United States Patent and Trademark Office

APPLICATION NO.	FIL	ING DATE	FIRST NAMED INVENTOR	ATTORNEY DOCKET NO.	CONFIRMATION NO.
10/622,894 07/18/2003		Hardayal Singh Gill	HIT1P029/HSJ9-2003-0109US	HIT1P029/HSJ9-2003-0109US 5016	
50535	7590	05/19/2005	•	EXAMINER	
ZILKA-KOTAB, PC				HEINZ, ALLEN J	
P.O. BOX 721120 SAN JOSE, CA 95172-1120				ART UNIT	PAPER NUMBER
				2653

Application No.	Applicant(s)					
	0	10/622,894	GILL, HARDAYA	L SINGH				
	Office Action Summary	Examiner	Art Unit					
		A. J. HEINZ	2653					
Period fo	The MAILING DATE of this communication or Reply	appears on the cover sheet	with the correspondence a	ddress				
THE - Exte after - If the - If NO - Failt Any	ORTENED STATUTORY PERIOD FOR RI MAILING DATE OF THIS COMMUNICATIOnsions of time may be available under the provisions of 37 CF SIX (6) MONTHS from the mailing date of this communication period for reply specified above is less than thirty (30) days, period for reply is specified above, the maximum statutory pure to reply within the set or extended period for reply will, by streply received by the Office later than three months after the end patent term adjustment. See 37 CFR 1.704(b).	ON. FR 1.136(a). In no

Sheet 7 of 8

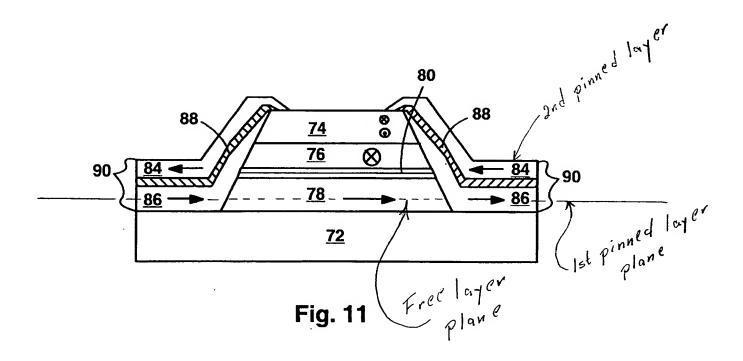
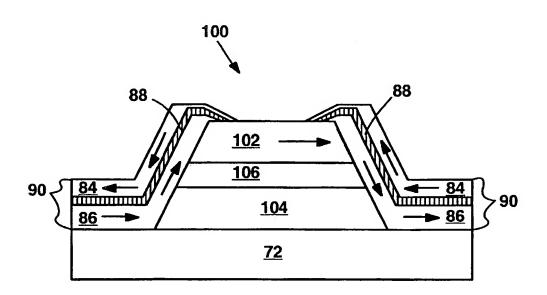
- (e) the invention was described in (1) an application for patent, published under section 122(b), by another filed in the United States before the invention by the applicant for patent or (2) a patent granted on an application for patent by another filed in the United States before the invention by the applicant for patent, except that an international application filed under the treaty defined in section 351(a) shall have the effects for purposes of this subsection of an application filed in the United States only if the international application designated the United States and was published under Article 21(2) of such treaty in the English language.
- 4. Claims 13,15,18&20 are rejected under 35 U.S.C. §102(b) as being anticipated by Carey.

See Fig. 11. Note, to the extent claimed and understood, the structure as shown in Addendum A reads on and performs to the same degree as claimed.
